Access Compliance Report Public Rights-of-Way (Pedestrian Signals)

Main Street: **BEACH_BLV** Cross Street: **CHAPMAN_AVE** Location: **SE**

ADA ID: **SGRK210928151922** Signal Type: **One Push Button-APS** Overall Compliance: **No** Severity Scores: **BTN 1: 25** **BTN 2: N/A** **No BTN: N/A**

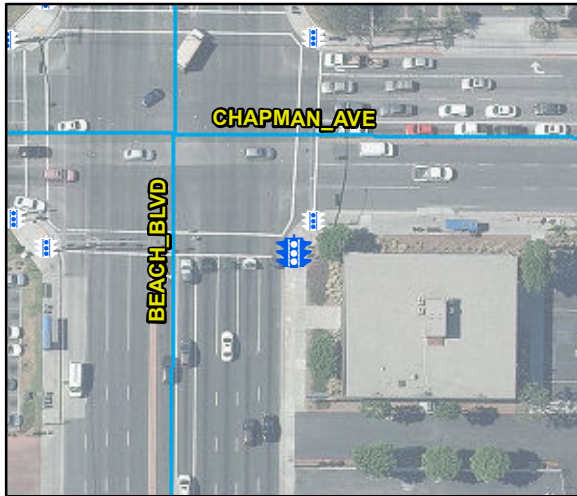
OC Std/PROW: **R404.2**

Possible Solutions: Remove and Replace Clear Space.
